Agenda - Planning Reports Ordinary Council Meeting

Tuesday 20 October 2009

- 5 [PR-CM] DA09/0466 - RISE Concept Plan Comprising Residential Retirement Living, Retail Commercial School and Open Space Precincts (MP08_0234) at Lot 1 DP 595529, Lot 1 DP 1033810, Lot 1 DP 1033807, Lot 4 DP 822786, Lot 31 DP 850230, Lot 2 DP 867486 and Lot 33 DP 1085109 Marana Street; Lot 31 DP 850230 Conmurra Avenue; Lot 2 DP 555026 147 McAllisters Road, Bilambil Heights**

The purpose of this report is to seek Council's endorsement of the proposed submission to the Department of Planning on the Major Project Application (Concept Plan and State Significant Site Application) for the Bilambil Heights "Rise" Residential Community Development (MP08_0234).

PLAN OF PROPOSED HEIGHTS UNDER STATE SIGNIFICANT SITE APPLICATION

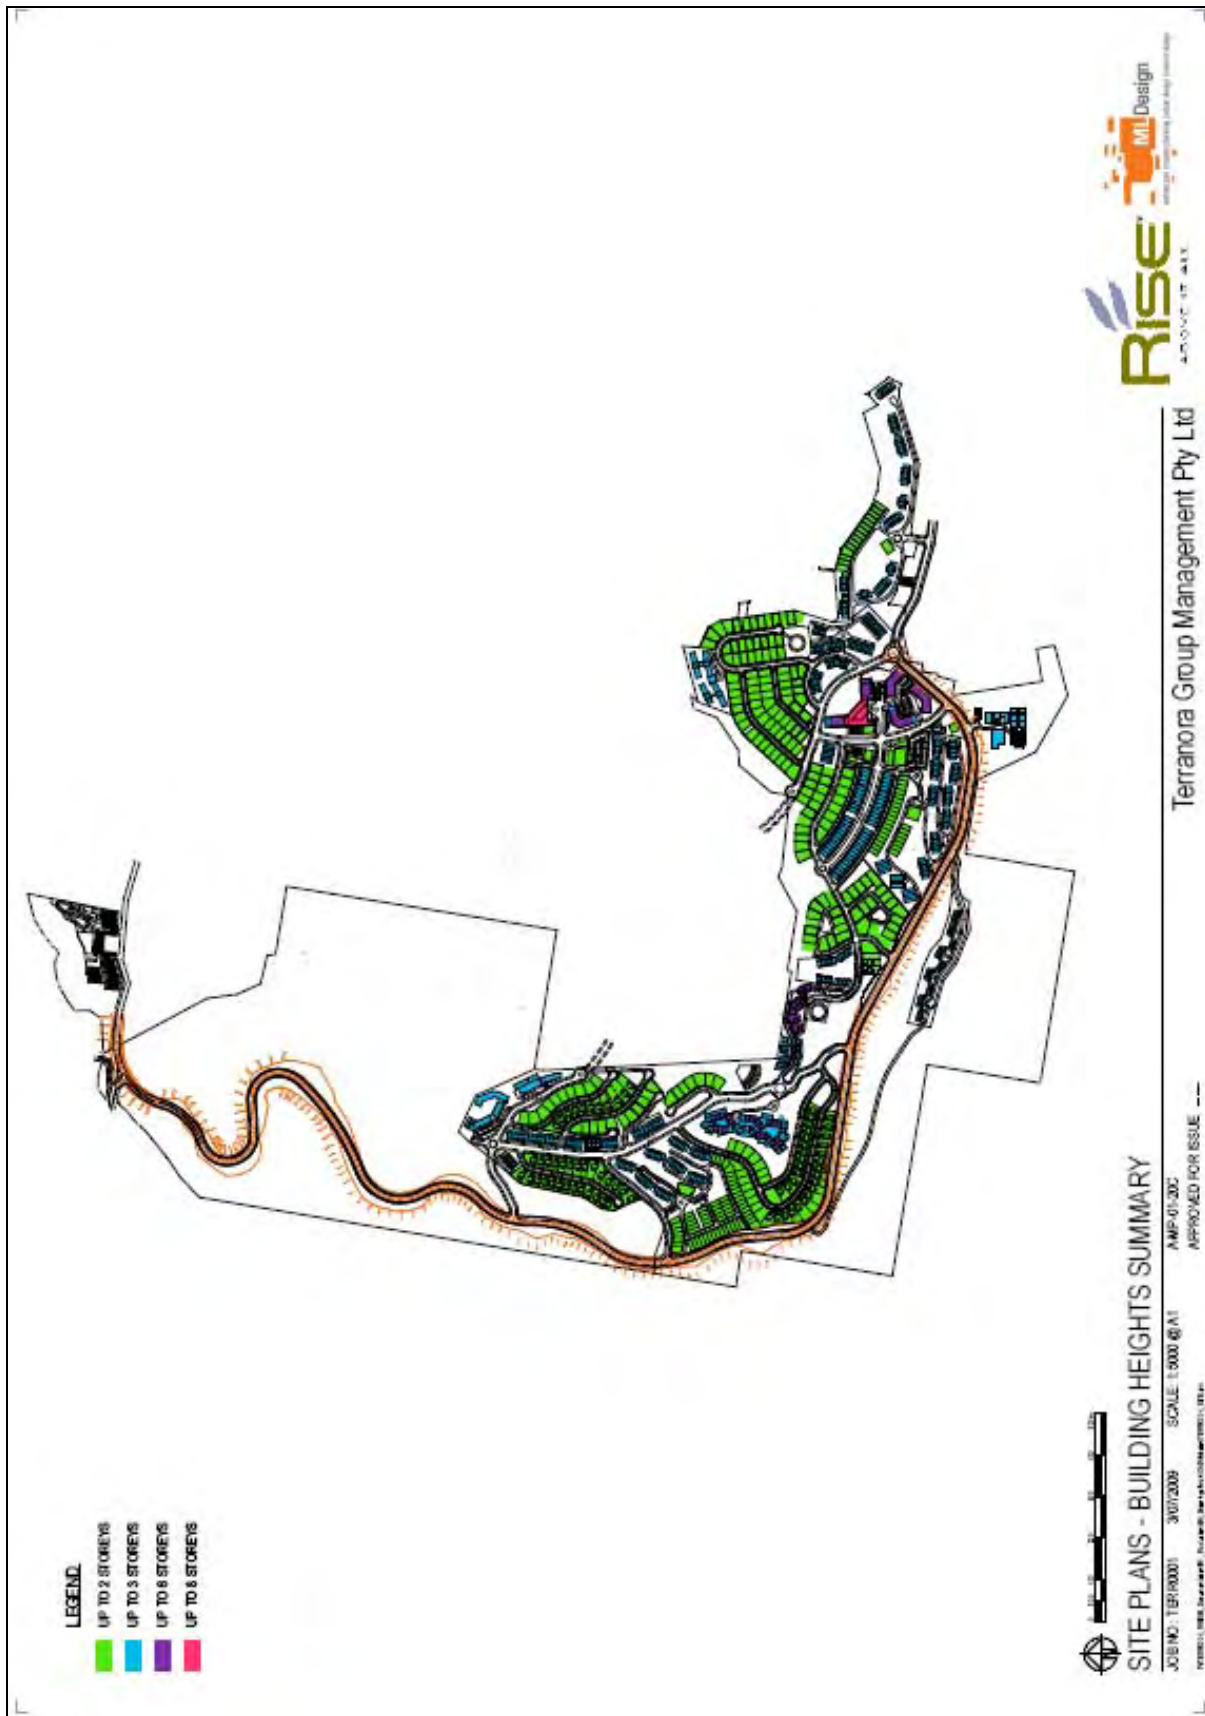
The applicant has requested a variation to the statutory height limit of three stories in certain parts of the site. The applicant proposes a height limit of up to 8 stories as shown on the following plan:

The application has not satisfactorily demonstrated the public benefit associated with the proposed increase in height and accordingly it is recommended to the Department of Planning to retain the existing height limits in place for the site.

Extract from Concept Plan with Local Area Structure Plan Image:

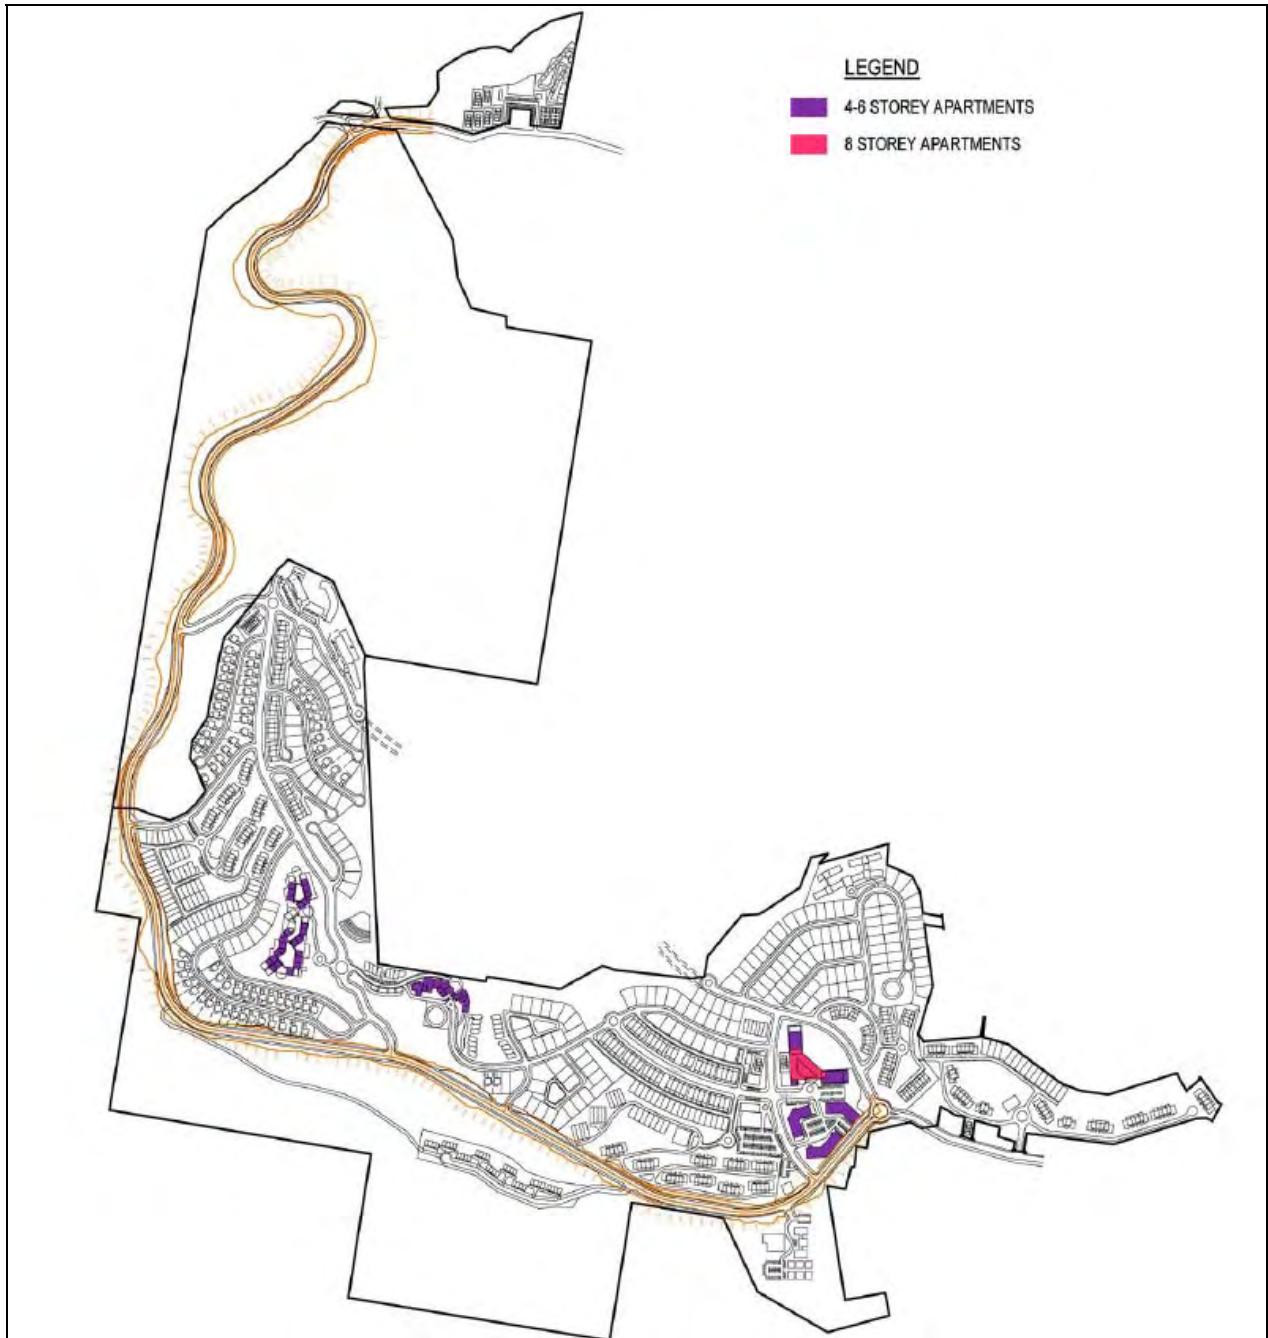
The Local Area Structure Plan was not publically exhibited and was never formally reviewed or reported to Council for any resolution. However, the applicant has indicated that verbal feedback was given by Council staff regarding the comprehensive nature of the Plan.

It is now understood that the Department of Planning has determined that the subject site (Rise) is large enough in its own right to be regarded as a State Significant Site independently of any other adjoining land that forms part of the Bilambil Heights Urban Land Release Area.

Whilst this might be true should the Department approve this concept plan it will have ramifications for Council's future planning of the remainder of the release area.

That Council request that a report is brought forward outlining the options available to advance the strategic planning for Bilambil Heights Release Areas (including options in regards to the status of the Local Area Structure Plan prepared on behalf of the "Rise" development)
